# City of Richmond Department of Planning & Development Review

**PROPOSAL:** Final location, character, and extent review of a new equestrian center for the Richmond Police Department.

**CITY OF RICHMOND, VIRGINIA  
RICHMOND POLICE EQUESTRIAN CENTER**

**Project Narrative  
For  
Urban Design Committee 'Final' Review**

**4 WEST ELEVATION**  
A2.1.1 | A4.1 | 1/8" = 1'-0"

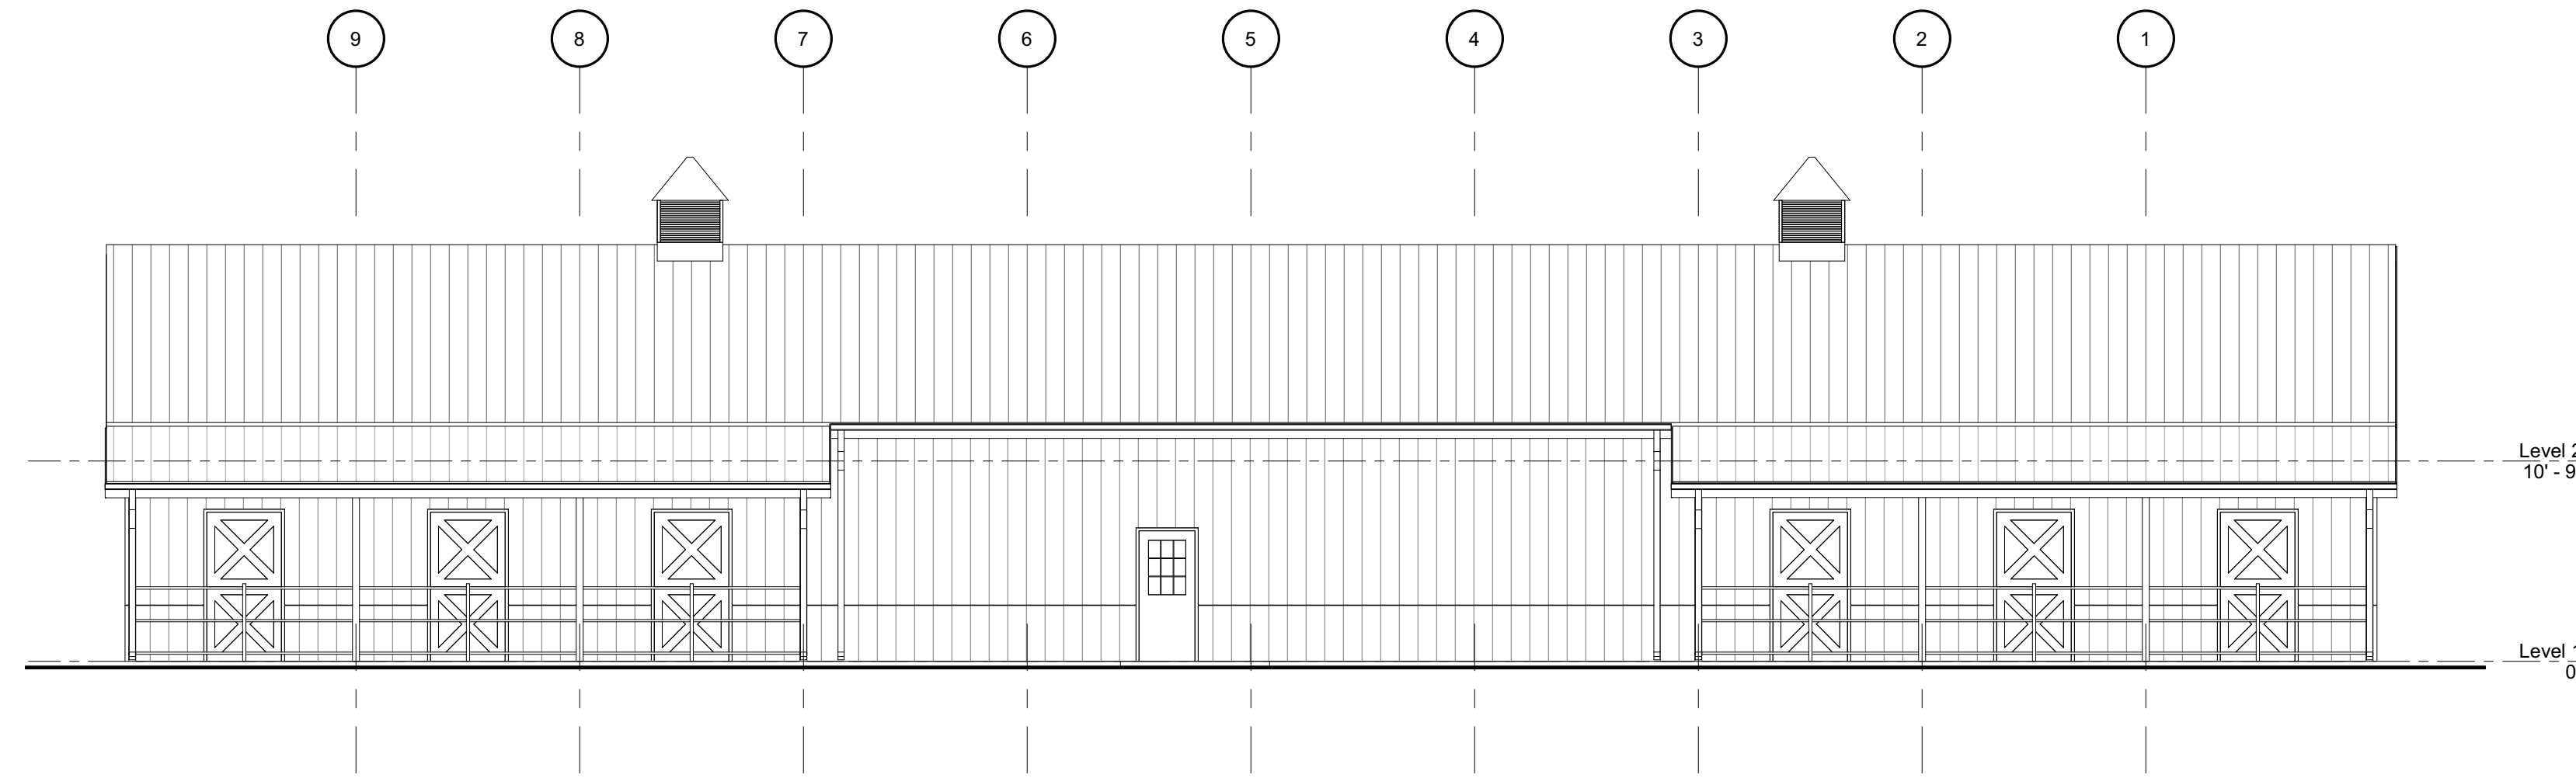
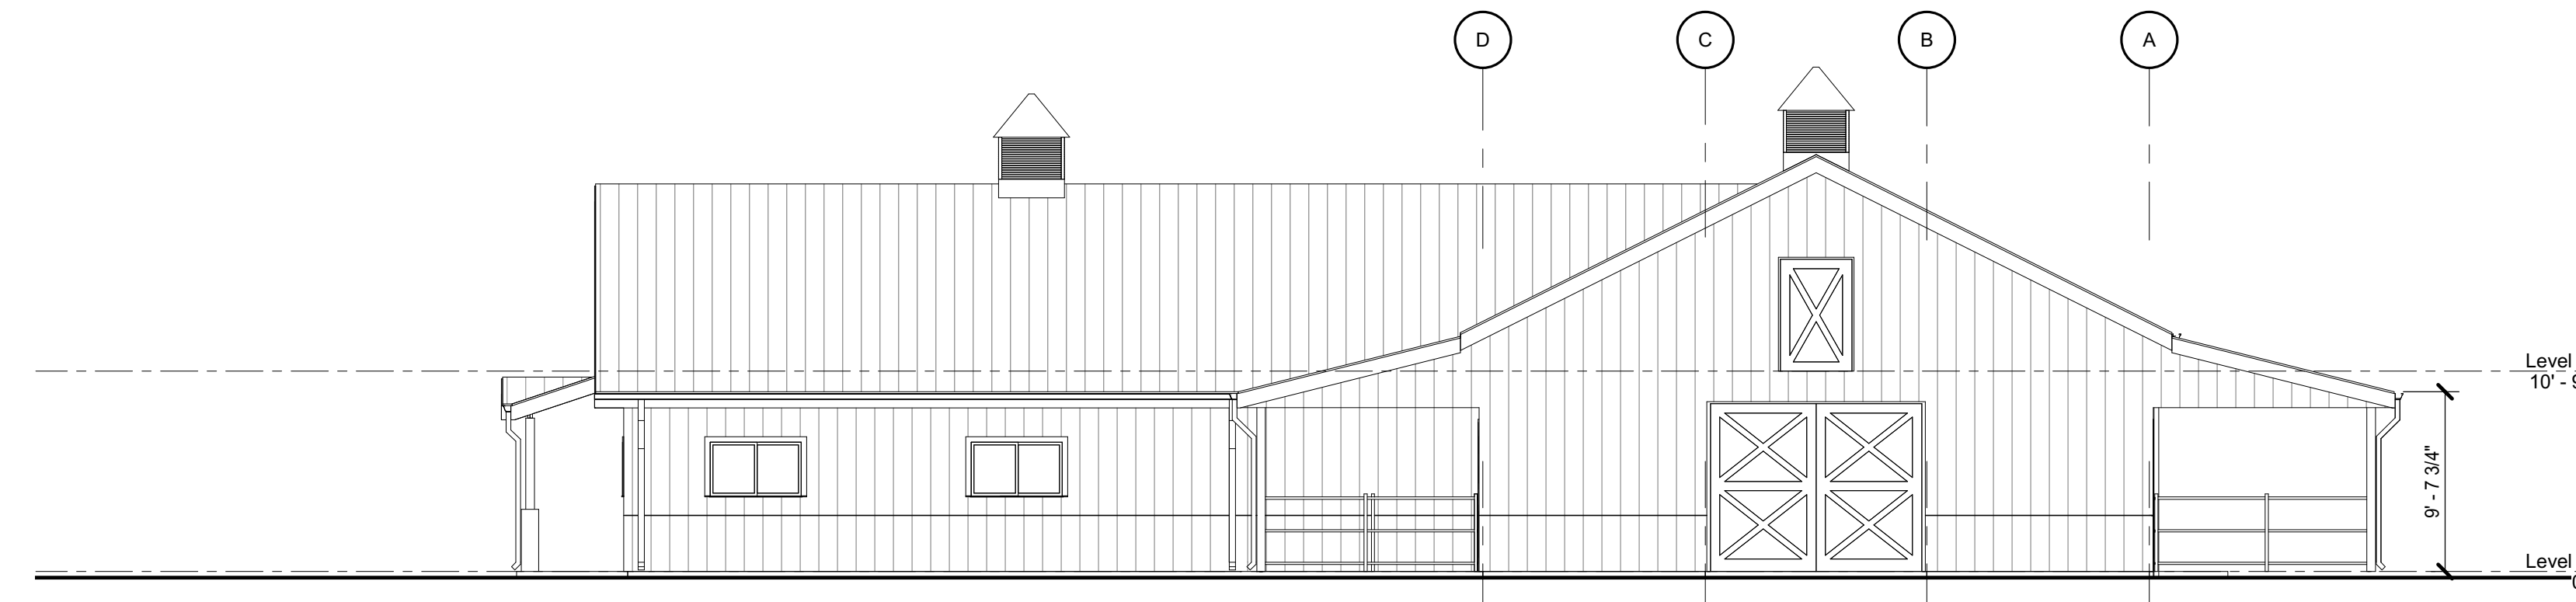
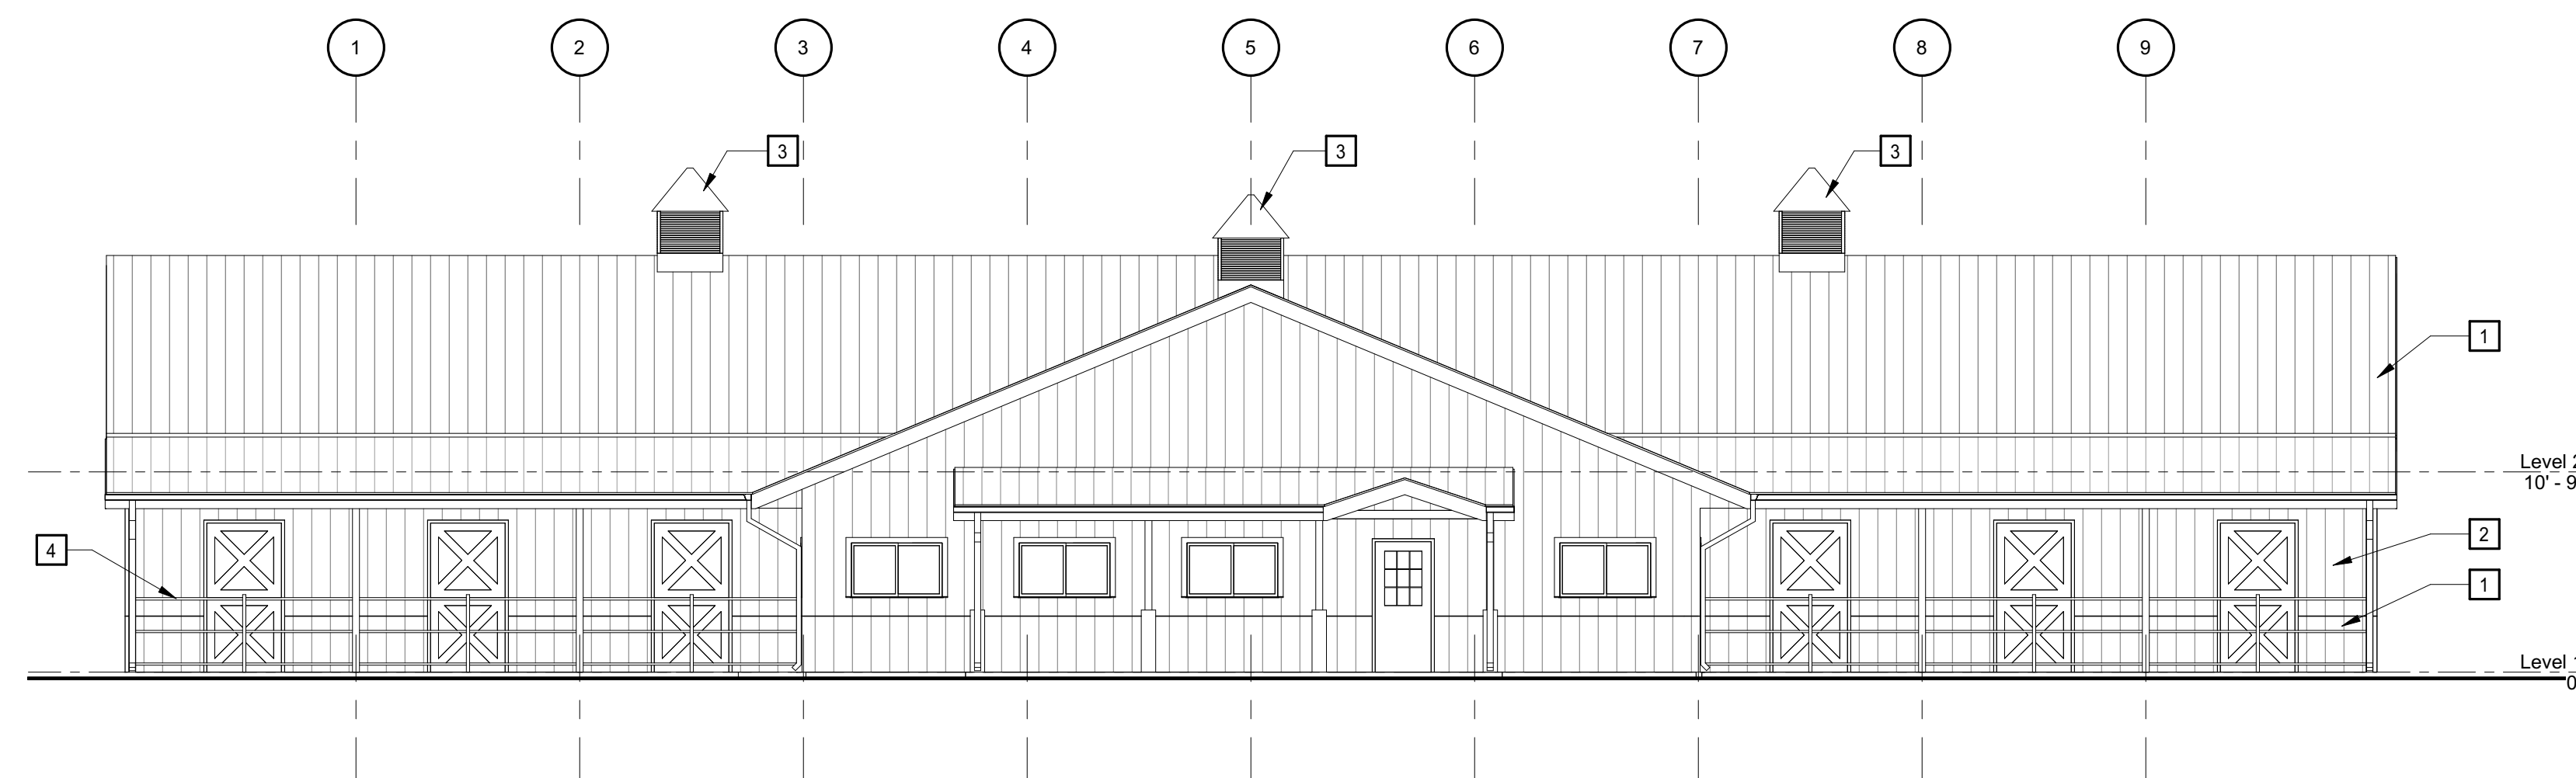
1. Consider changing the proportion and size of the windows:

The windows sizes were increased and the proportions refined. The sill height of 48 inches was retained for passive security purposes so that officers are not visible when seated in the rooms.

**RVA Police Equestrian**  
**Site Plan rev050418**

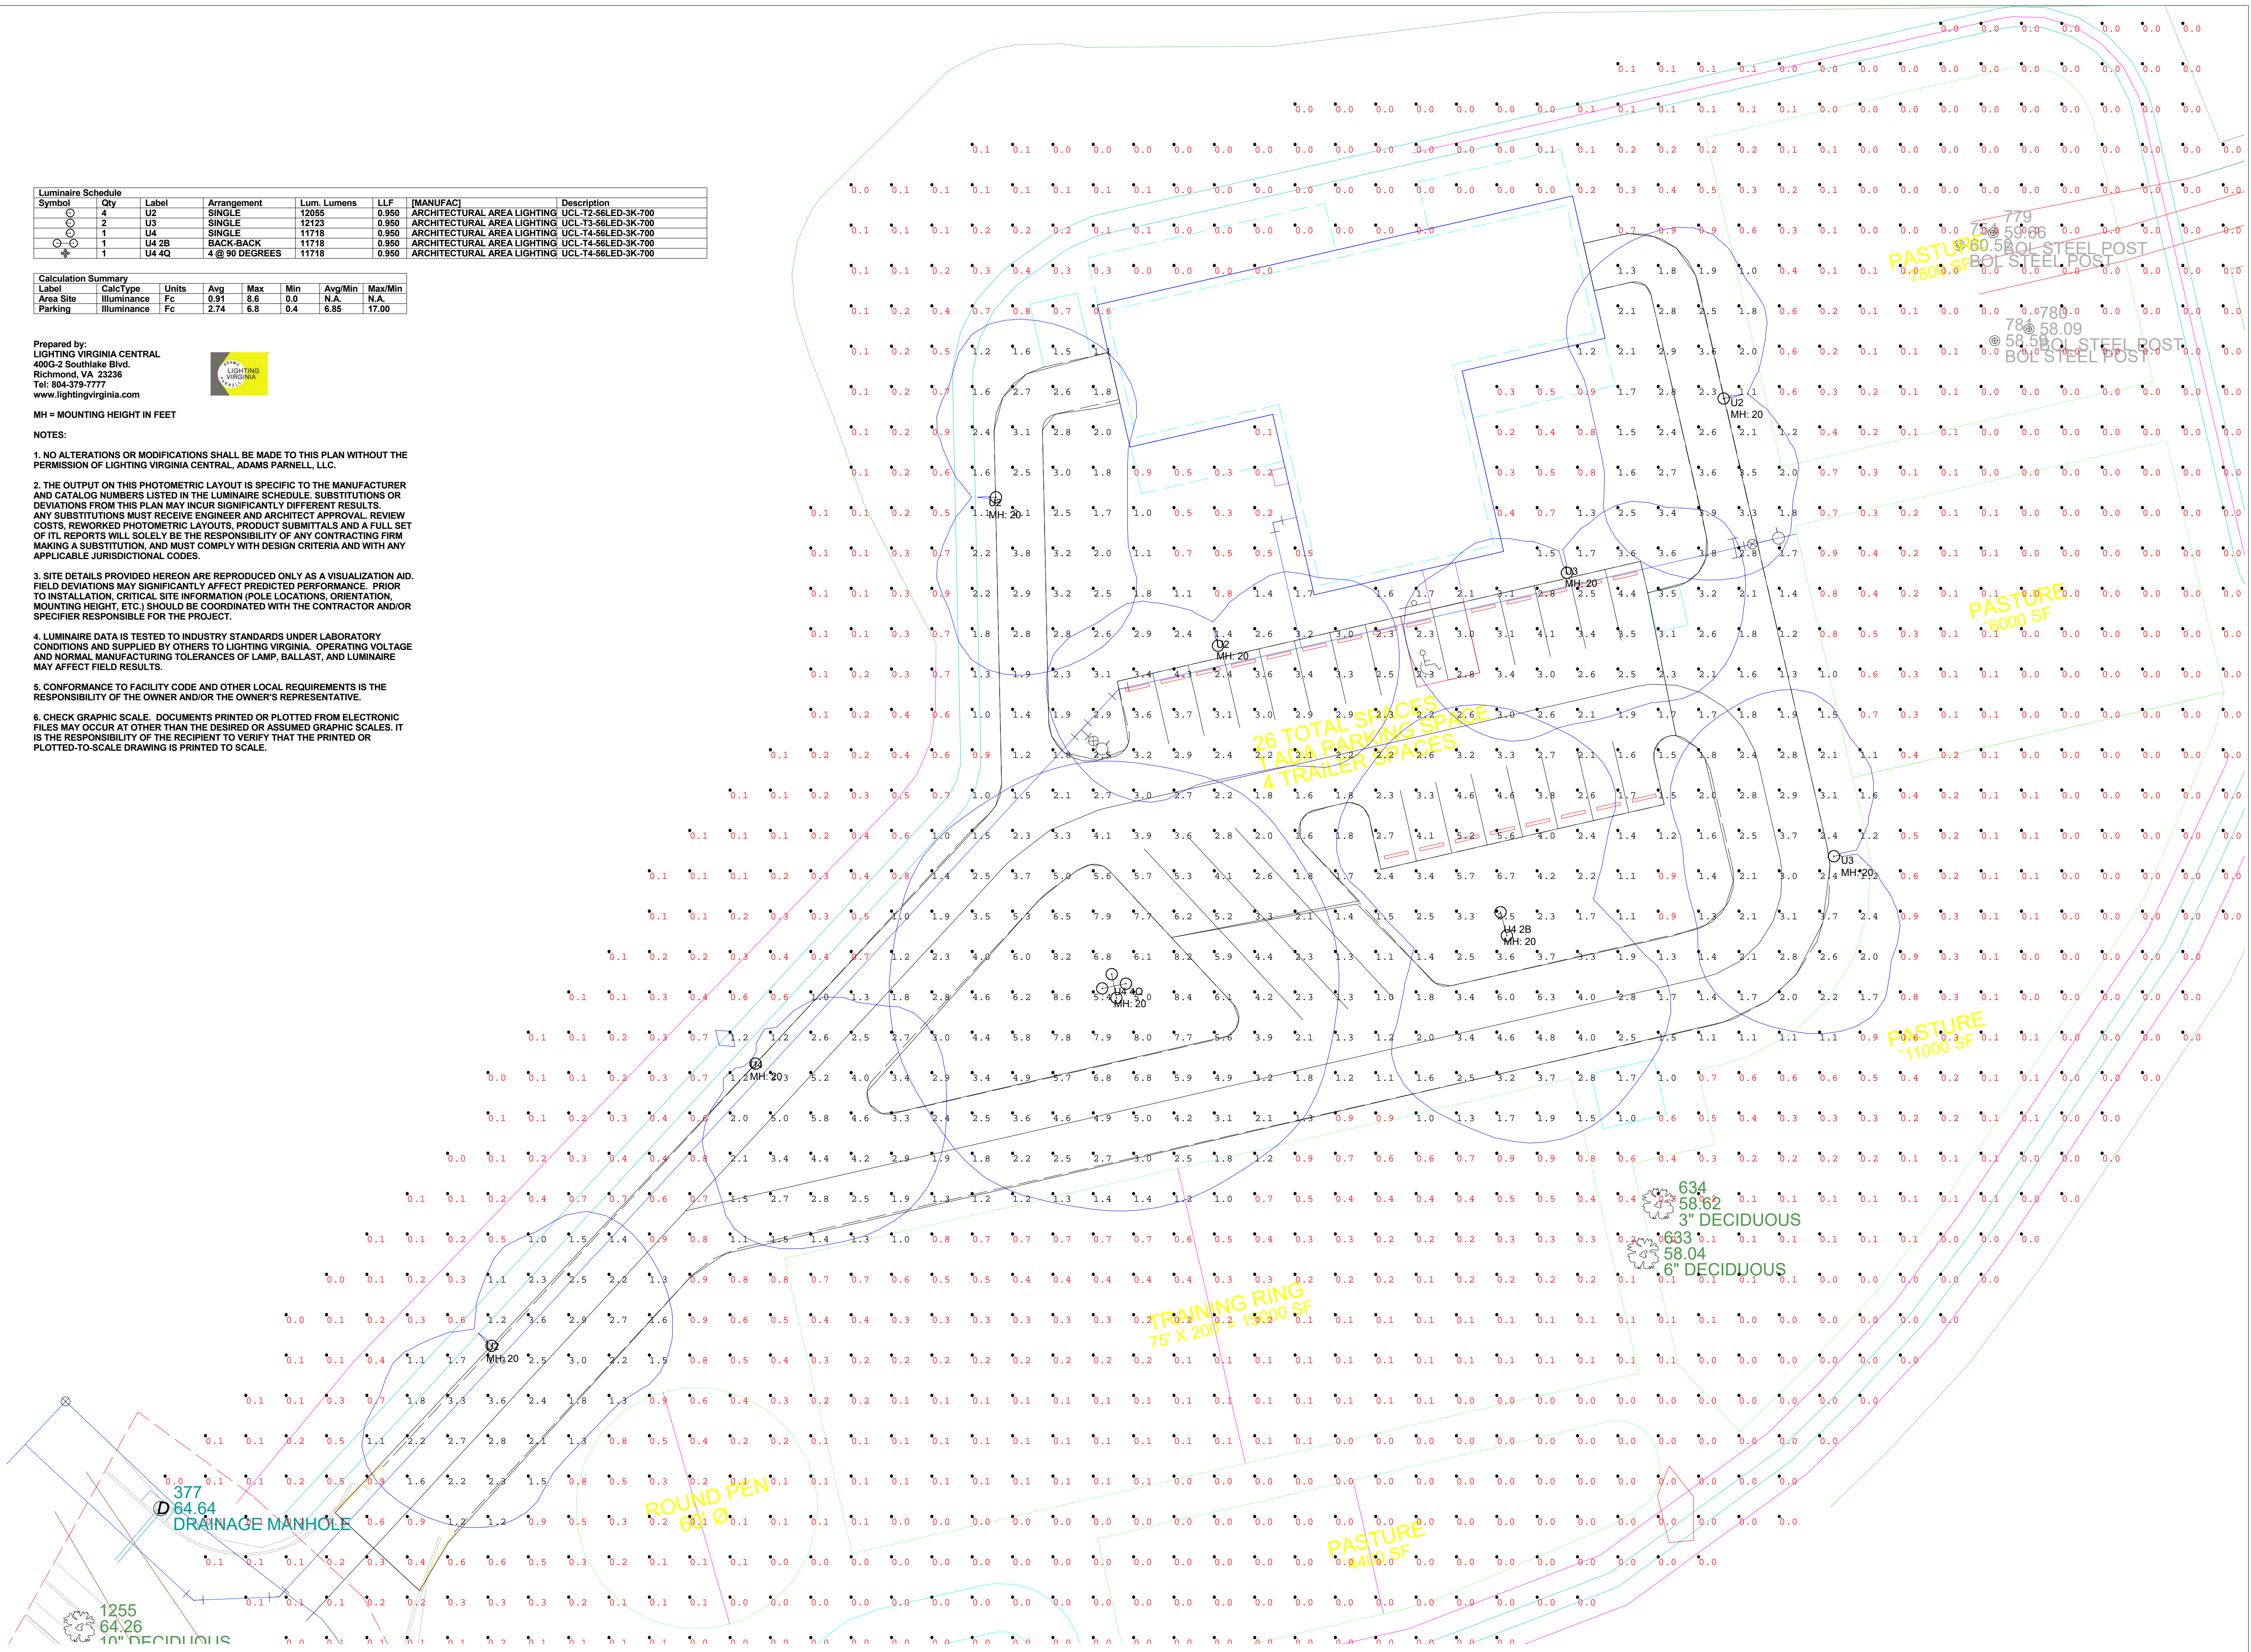
7. Please provide a site lighting plan and specify full cutoff LED fixtures with a color temperature of 3,000k.

This request was incorporated into the design. A photometric site plan has been included that illustrates there is no light trespass onto adjacent properties. Cut sheets are included with this submission for the proposed fixture.
